EAGLE MOUNTAIN PLANNING COMMISSION MEETING

October 25, 2016

EAGLE MOUNTAIN CITY

Project: Brandon Park
Applicant: Paul Linford/Plumb Holdings EM LLC
Request: Concept Plan Review
Type of Action: Discussion Item

Concept Plan

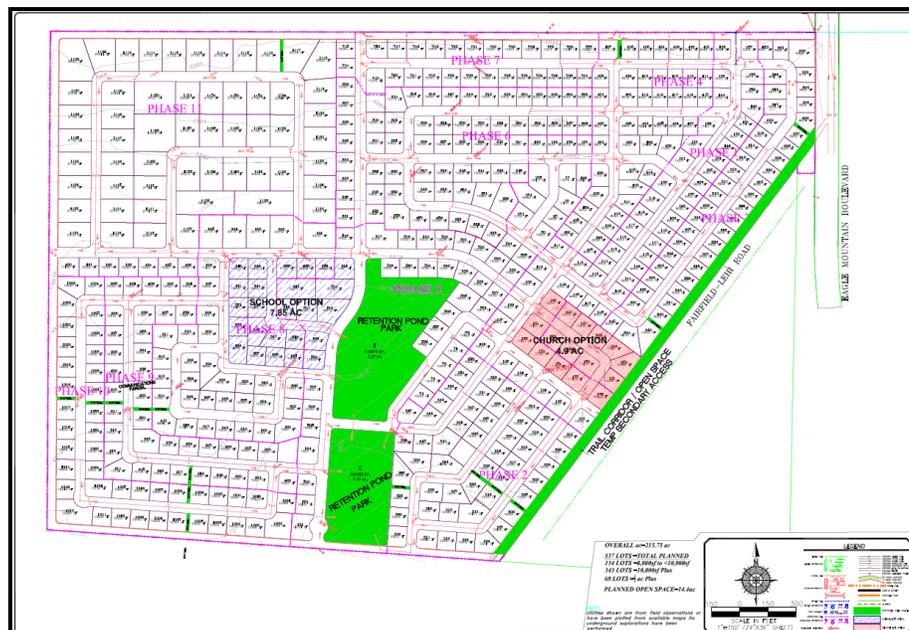
This proposal has been updated since the first presentation to the Planning Commission. The applicant has addressed different concerns that the Planning Commission and City staff had. This land was previously known as Equestrian Estates and was brought to the City in 2007 for approval. The proposal for Equestrian Estates was never completed. Brandon Park Estates was review in January 2016 and in September 2016 this is a revised plan.

roads. There are roads to the north, south and west of the proposal. As this project moves forward the property for these roads will need to be dedicated to the City at the proper time. The proposed collector road to the south is to be constructed through a portion of Pony Express Park and connect into Majors Street in the Overland Trails development. This proposal shows future access to projects to the south, west and north.

With the current density of this project at 2.47 units per acre, 12.33 acres of improved open space will be required and 1232 amenity points. The applicant is showing 14.40 acres of improved open space it is yet to be determined if all the proposed open space will be counted as improved open space because of the proposed detention and trail along the Pony Express Trail. The property for Pony Express trail will need to be dedicated to the City. An overall landscape plan will need to be submitted.

The applicant can begin the project with a maximum of 30 home-sites off of a single access. In order for the applicant to get approval for more than 30 lots two accesses into the project must be provided per fire code. The applicant has spoken with the Fire Marshal and is proposing the two accesses are located on the road to the north of the project. The applicant has proposed a temporary access on the east of the project accessing the current Lehi-Fairfield road. The Lehi-Fairfield road will eventually become a regional trail for the City. One thing to be aware of is the road to the north with the two accesses connects with Eagle Mountain Blvd at only one location.

Staff has concerns with the surrounding properties having access. At this time none of the surrounding proposed collector roads have been built. With none of the collector roads being built at this time access to the property to the south and possibly to the west would be restricted. The applicant has shown on this plan future access to surrounding properties.
